Item Name: Aft Crosstube - High

Work Order ID 119715

DRAWING NO. D212-664-241	TITLE CROSSTUBE ASSY (205/212 HI AFT)	REV. D	DART AEROSPACE LTD. ENGINEERING ORDER		D.E.O. NO. D212-664-241-D-1	SHEET NO. SHEET 1 OF 2	SCALE NTS
DRAWN	CHECKED	MFG. APPR.	APPROVED	DE APPR.			
DATE 11.04.07	DATE 11.04.11	DATE 11.04.12	DATE 11/04/12	DATE 11.04.12

**D212-664-241/-241B
ASSEMBLY DETAIL**

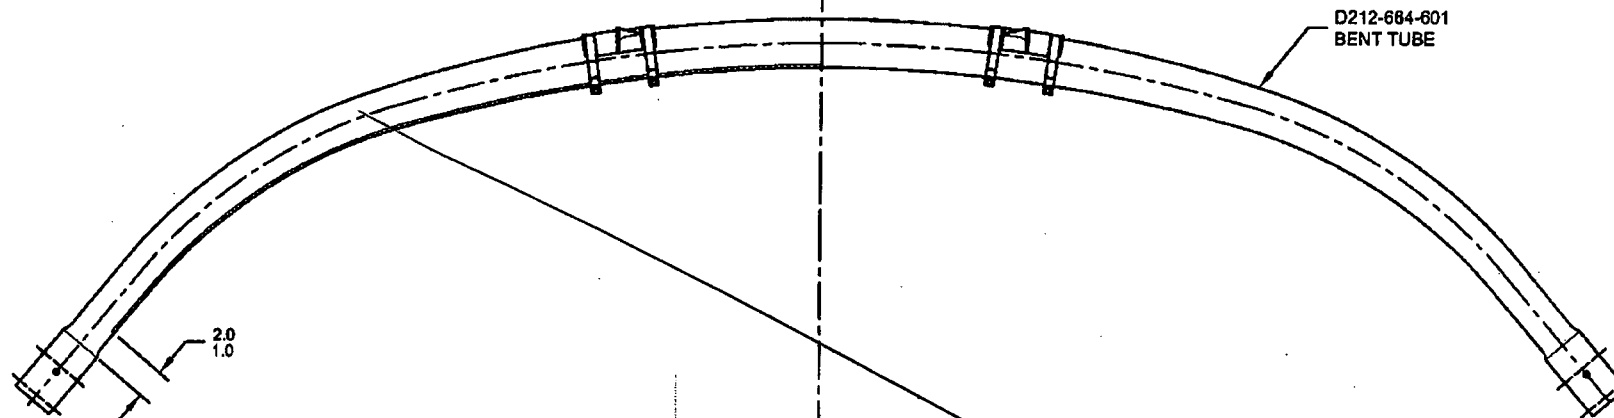
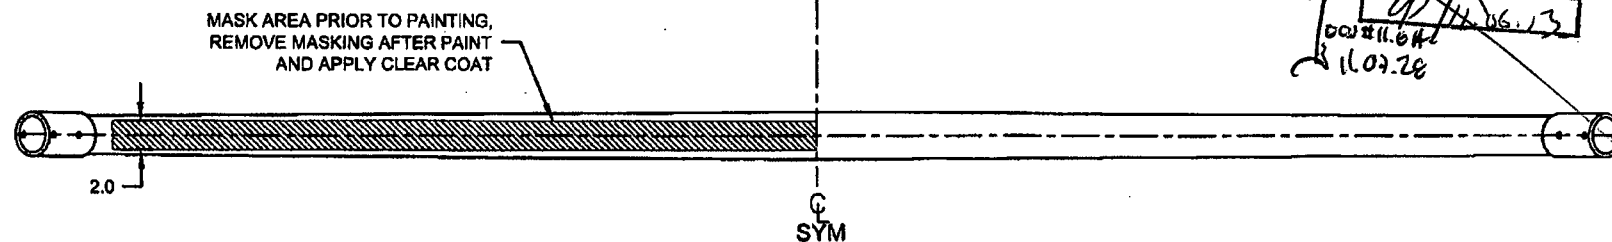
ADD AN INSPECTION WINDOW TO UNDERSIDE OF CROSSTUBE.

NOTES 2 OF SHEET 1 IS AMENDED AS FOLLOWS:

- 2) FINISH: CHEMICAL CONVERSION COAT PER DART QSI 005 4.1
PRIME INSIDE AND OUTSIDE PER DART QSI 005 4.2
MASK UNDERSIDE OF CROSSTUBE AS SHOWN (HATCHED AREA) AND
PAINT OUTSIDE PER DART QSI 005 4.2
REMOVE MASKING AND APPLY CLEAR COAT

FIGURE 1: SUPPORT INSTALLATION

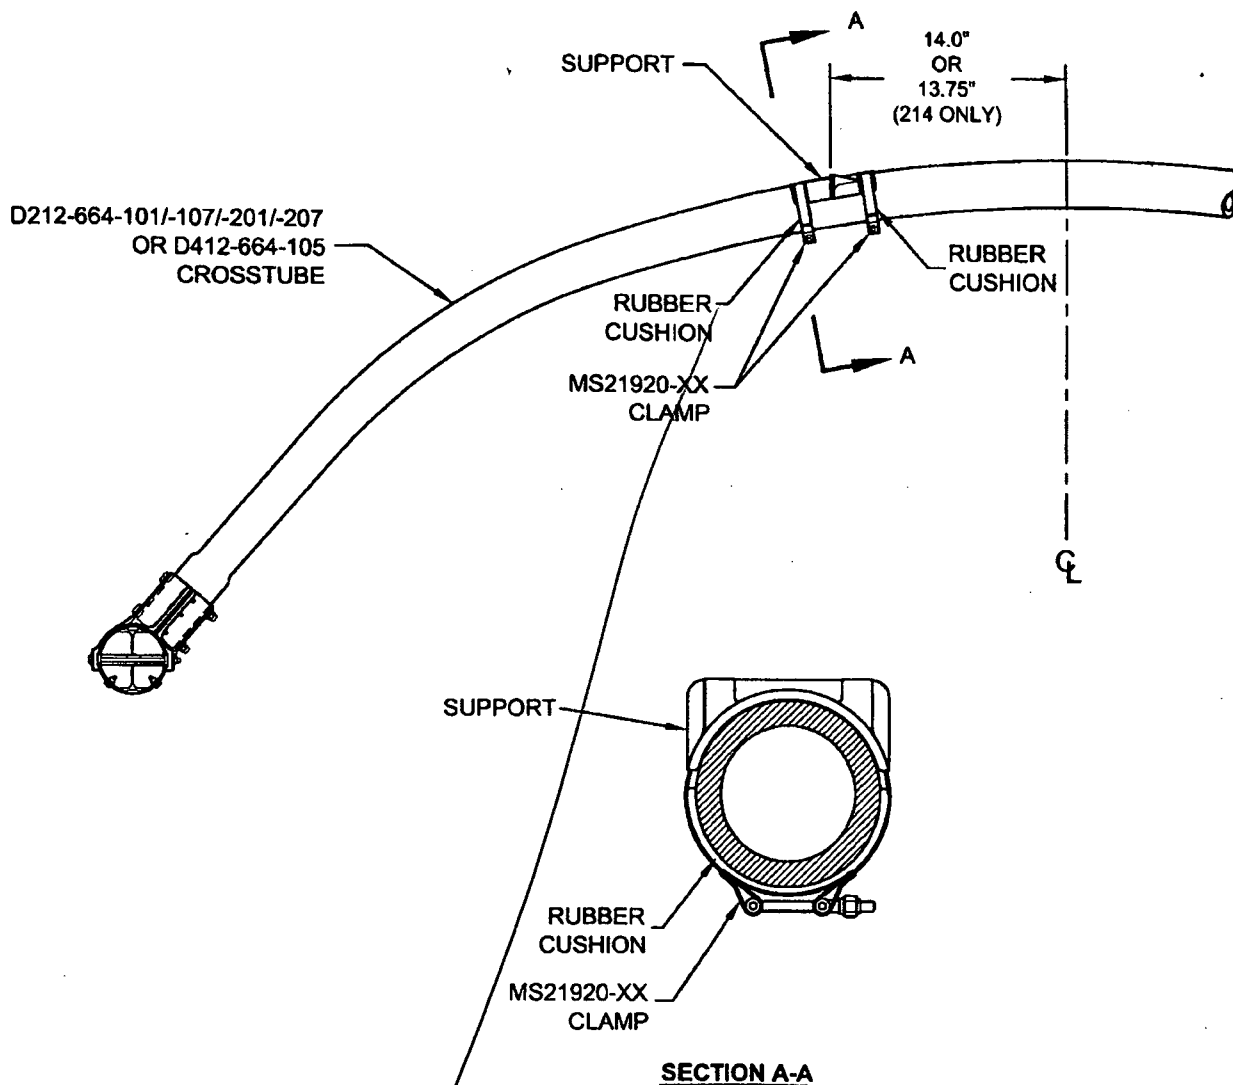
For the crosstubes listed above, section 32.4 of ICA-D212-664 is amended as follows. Use Figure 1 of this service instruction and Figures 32-2 to 32-9 of ICA-D212-664 for further reference. For crosstubes of an earlier change number, it is recommended that if the supports are removed, the supports should be reinstalled using the procedure listed below.

- 32.4.1 Locate the area on the crosstube for installation of support (see Figure 1 of this service instruction). For D212-664-101/-107/-201/-207 and D412-664-105 crosstubes, the outward face of the support tabs should be 14.0" (355mm) from the crosstube center for 204/205/210/412/UH-1 aircraft. For installation on 214B/B-1 aircraft, the outward face of the support tabs should be 13.75" (349mm). Ensure paint finish of crosstube is intact; touch up as required per Chapter 5 (5.3.9) of ICA-D212-664.

- 32.4.2 If present, remove any paint/primer on bottom of supports. Abrade mating surfaces of support and crosstube with 400-grit sandpaper. Saturate a clean cloth with MEK or 4105S Wash'n'Wipe Degreaser or equivalent and wipe until there is no residue.

- 32.4.5 Apply a 0.04" to 0.07" thick layer of Proseal 890 Class B or AMS-S-8802 Class B sealant underneath applicable support and install support as shown in Figure 1 of this service instruction.

- 32.4.6 Install the clamps opposite to crosstube support as shown in section A-A of Figure 1. Install rubber cushions underneath each clamp around the bottom circumference of the crosstube up to the crosstube centerline. Torque clamps 80-100 in-lb (9.0-11.3 Nm). It is acceptable to use smaller or larger sized MS21920-XX clamps than those listed in ICA-D212-664, ensure that after torquing the clamps per this instruction, the nuts are in safety but not bottomed out
